Ravalli County Off Road User Association

DARBY LUMBER LANDS – PHASE II PROJECT OBJECTION

This document constitutes the Objection to the Darby Lumber Lands – Phase II Project in the Bitterroot National Forest, Darby/Sula Ranger District. The Draft DN and FONSI for this project was released to the public on February 25, 2019. This Objection is submitted on behalf of the Ravalli County Off Road User Association (RCORUA).

EXHIBIT A

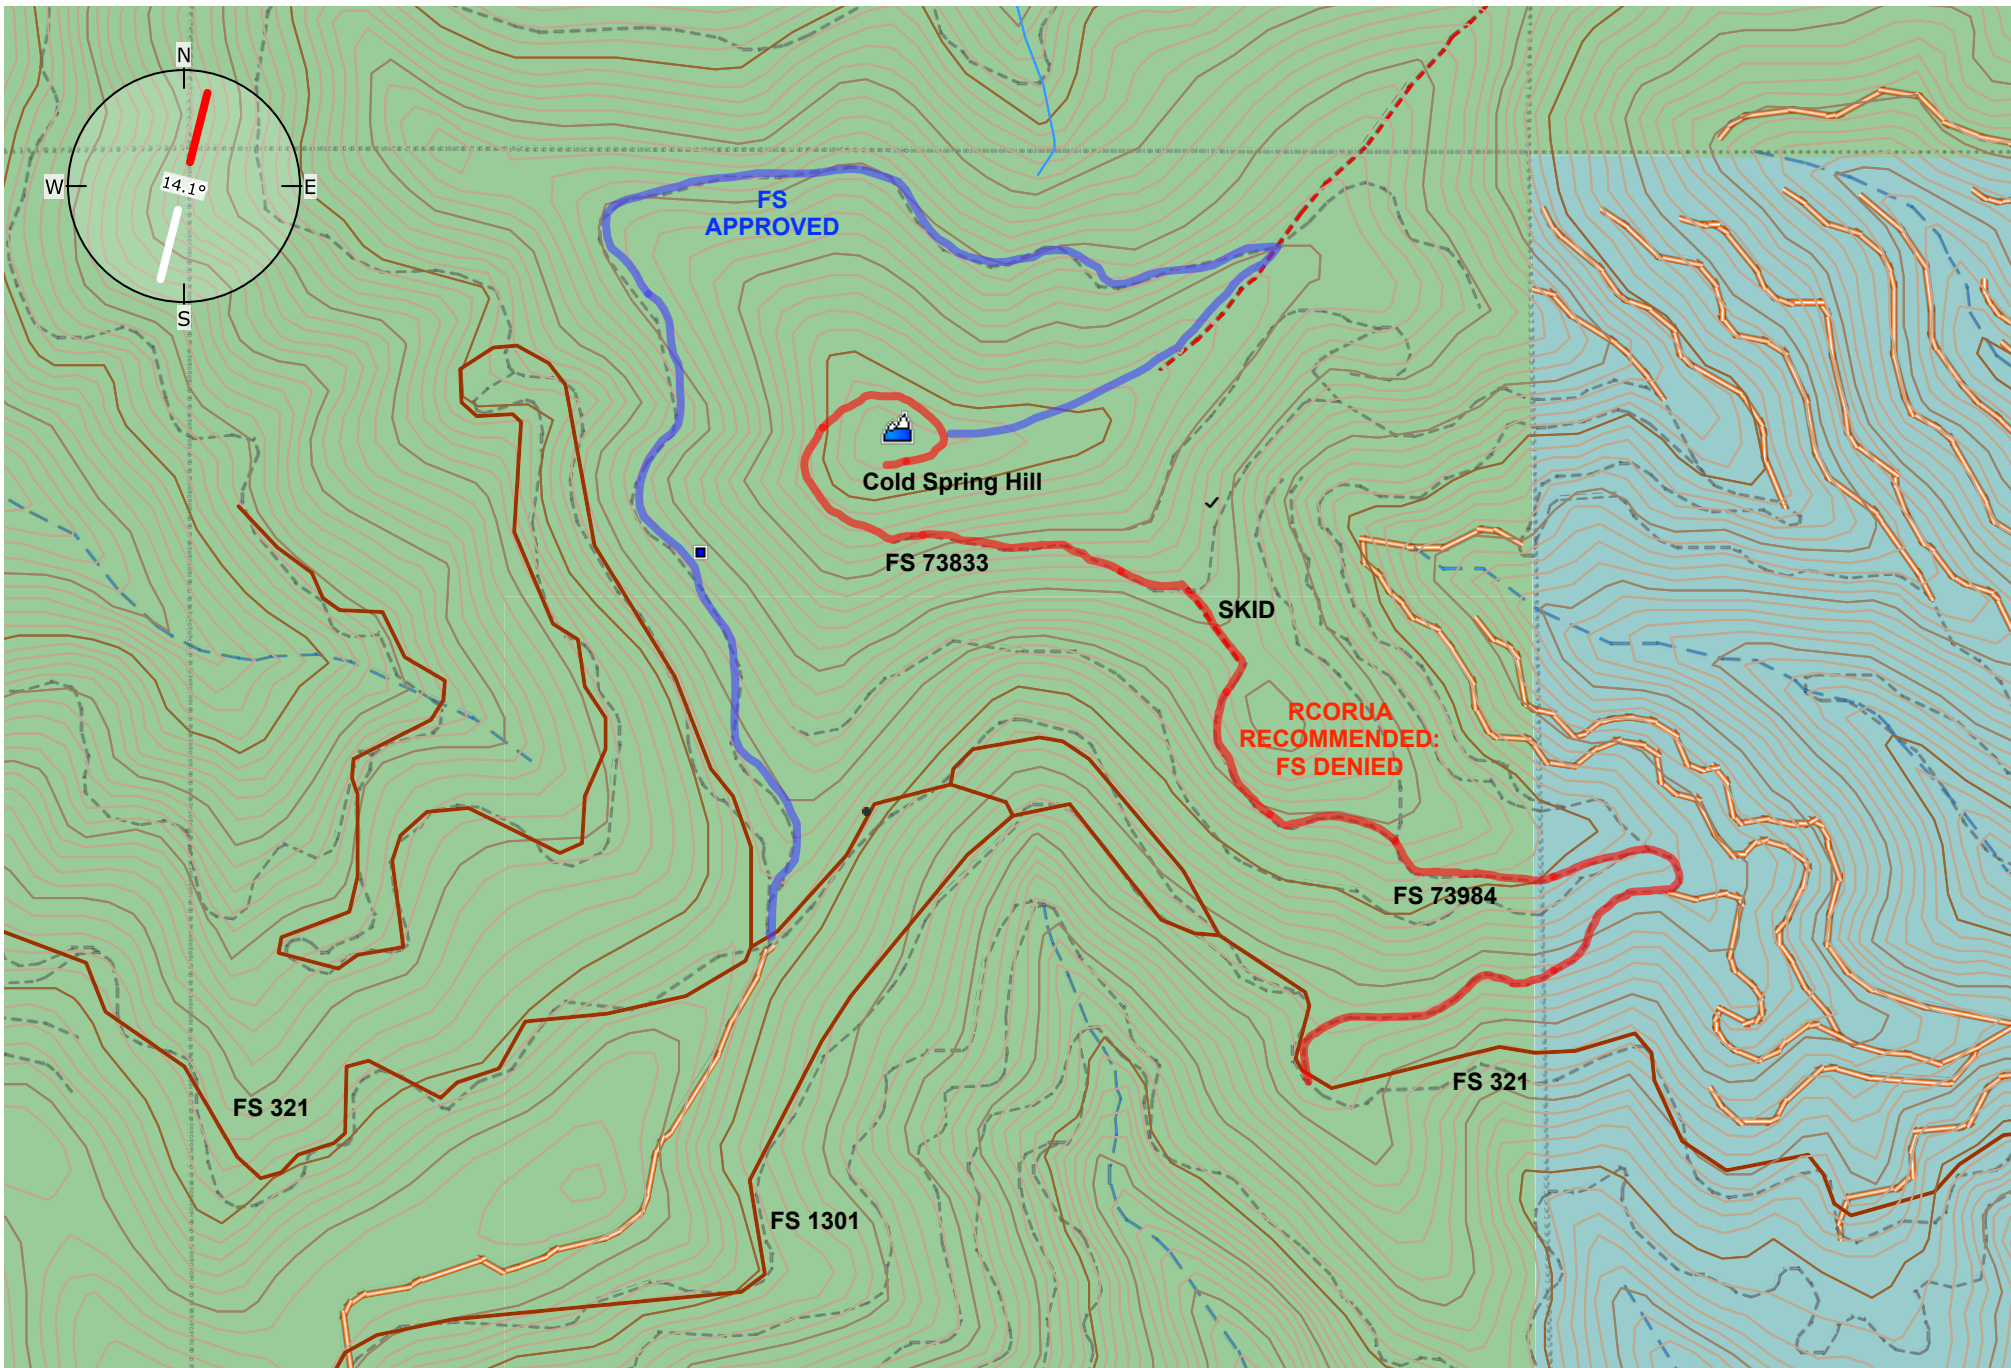
RCORUA's recommendation to the Agency in 2010 included an OHV loop route to the top of Cold Spring Hill. This loop route, portions of which have been modified and improved by the Forest Service, is shown on EXHIBIT A. The portion of this recommended loop route that is the subject of this objection is shown on red on EXHIBIT A, and referred to herein as "Cold Spring South".

EXHIBIT E

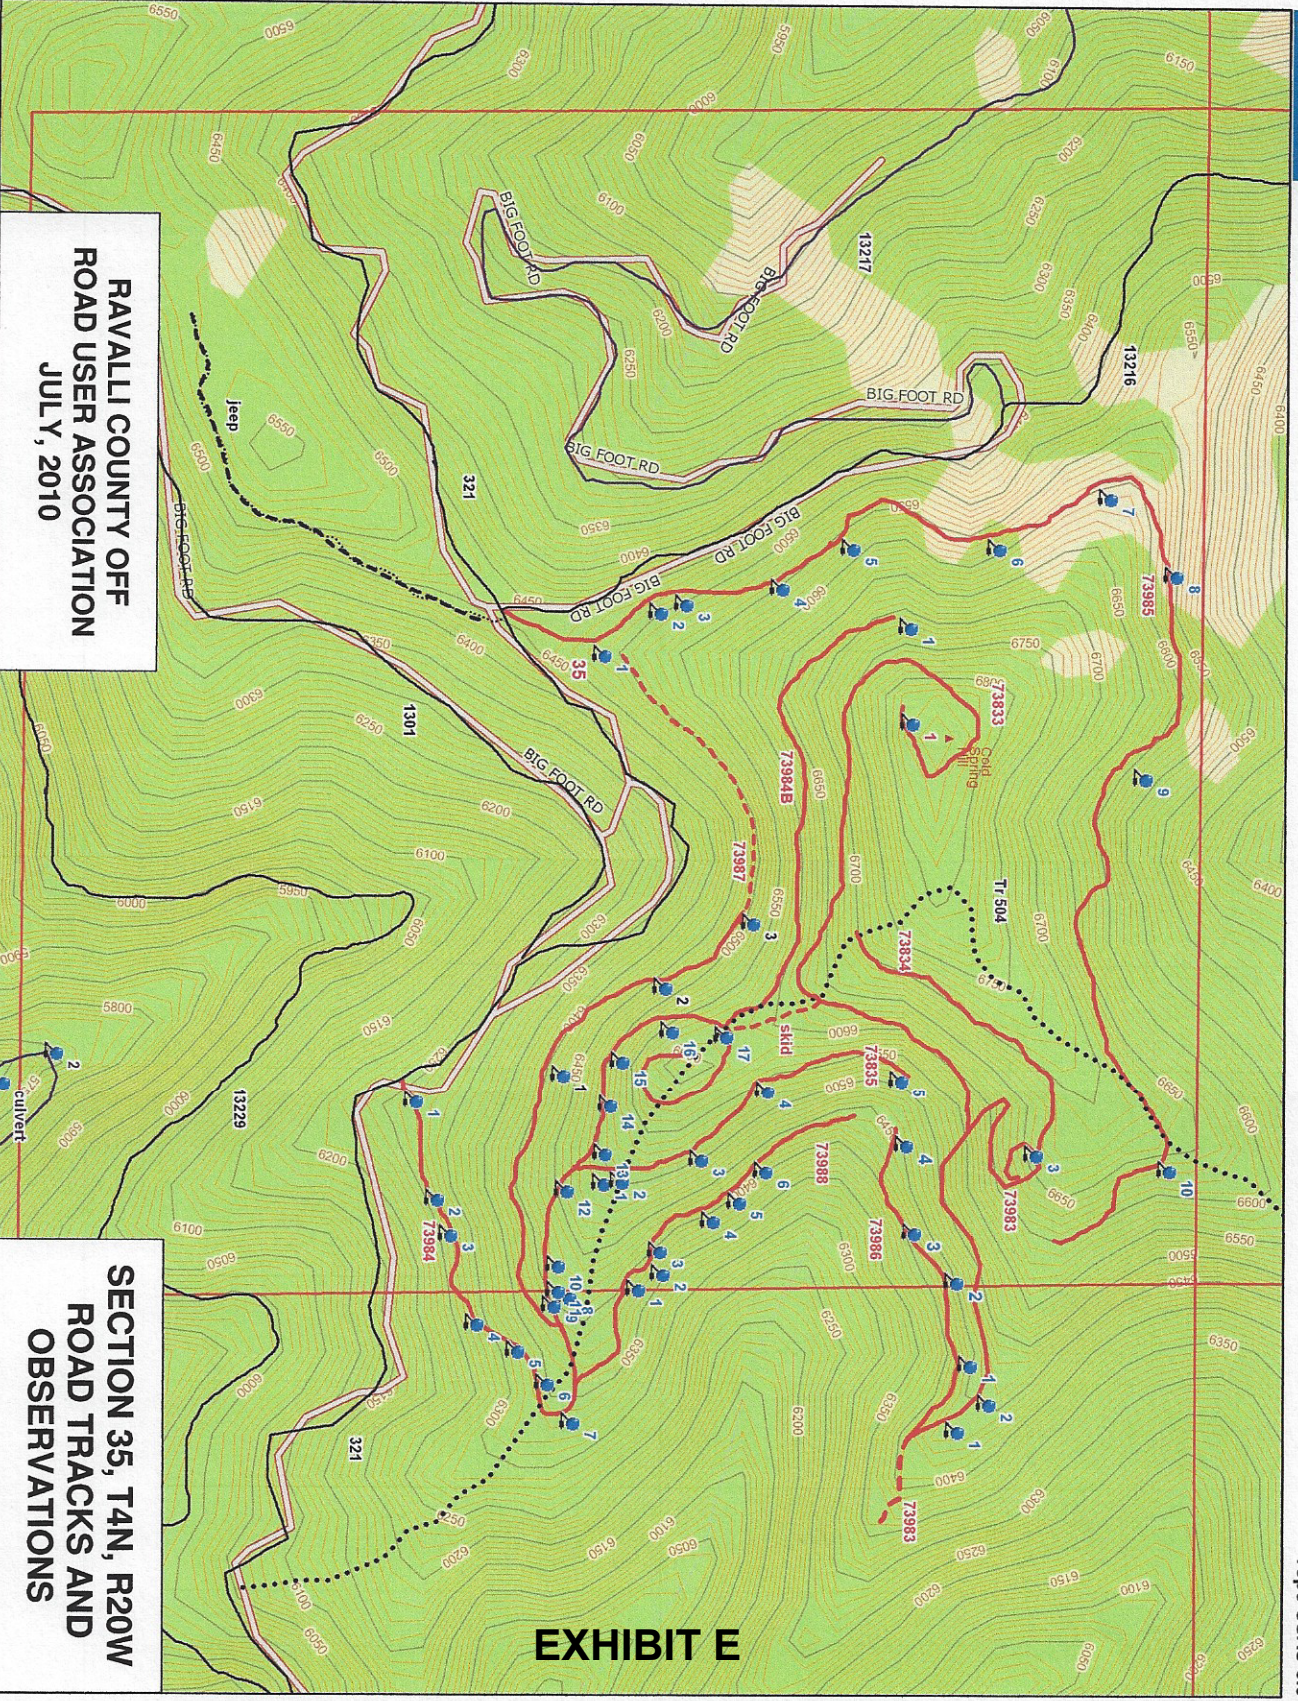
The roads involved in the Cold Spring Hill South route (FS 73833 and FS 73984) have been on the ground for at least three decades. During that time, the roads have been through many spring thaws and unusual rain events. According to RCORUA’s 2010 observations, there is no evidence of erosion or rutting on either of these roads. In other words, there is no evidence that these roads would be “difficult to maintain” as claimed in the Draft DN.
